PCN#20250725000.1

**Qualification of MIHO8 as an additional Fab site option and
TI CDAT as an additional Assembly site option for the Select Devices
Change Notification / Sample Request**

Date: July 28, 2025

Sample product shipping label (not actual product label)

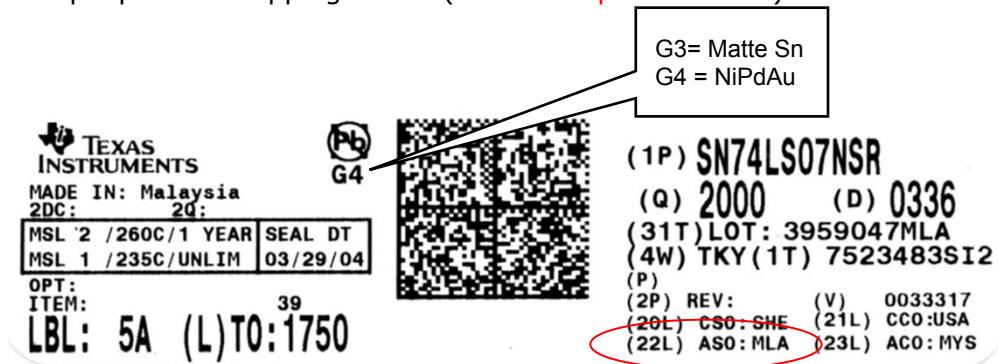
Changes to product identification resulting from this PCN:

Fab Site Information:

Chip Site	Chip Site Origin Code (20L)	Chip Site Country Code (21L)	Chip Site City
CFAB	CU3	CHN	Chengdu
MIHO8	MH8	JPN	Ibaraki

Assembly Site Information:

Assembly Site	Assembly Site Origin (22L)	Assembly Country Code (23L)	Assembly City
TFME	NFM	CHN	Chongchuan
CDAT	CDA	CHN	Chengdu
